RE: MESA RIDGE SUBDIVISION (E-11/D7A)
Engineers Certification for Release of Financial Guaranty
Engineers Stamp dated 7/7/2005
Engineers Certification dated 12/28/2006

**DRAINAGE STUDY
FOR
MESA RIDGE SUBDIVISION**

Re: Preliminary Construction Plans for Mesa Ridge Subdivision, ZAP E-11

Re: Drainage Study for Mesa Ridge Subdivision, ZAP E-11

SECTION B-B
CONCRETE RUNDOWN
NOT TO SCALE

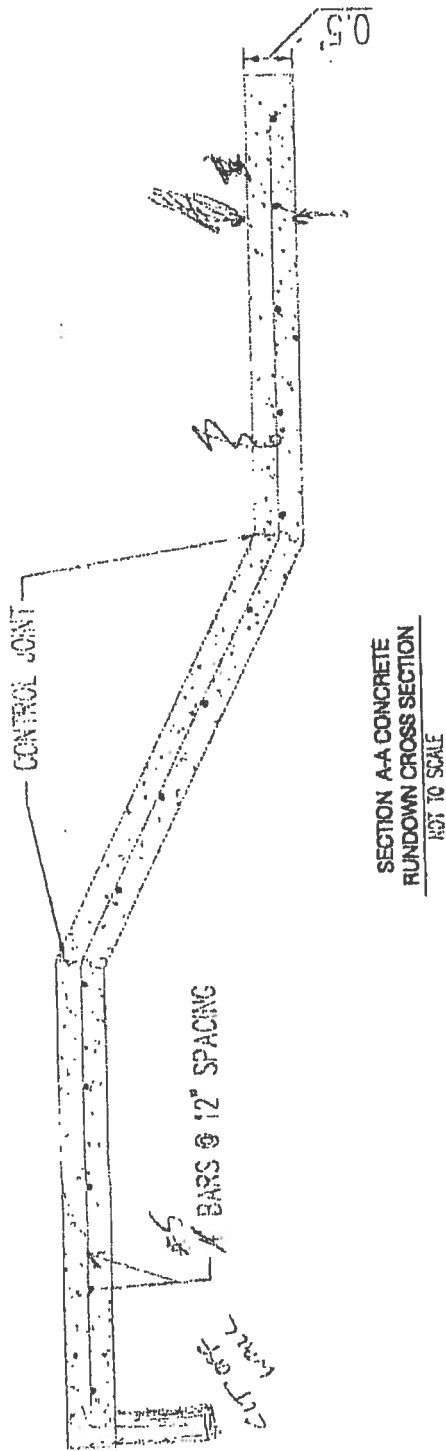
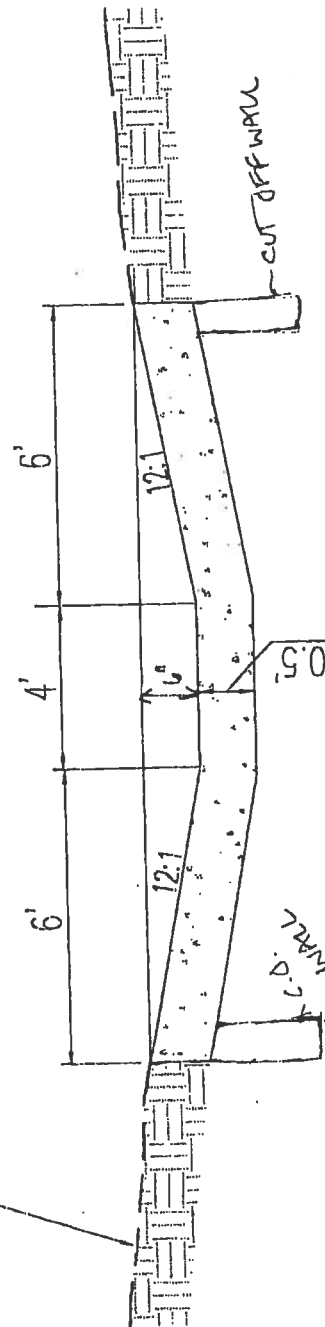
AMAFCA approves the drainage plan and the storm drain outfall to the Mariposa Diversion Channel. See the attached for comments on the detail Sheet 13.

WILL THIS WIDTH WORK?
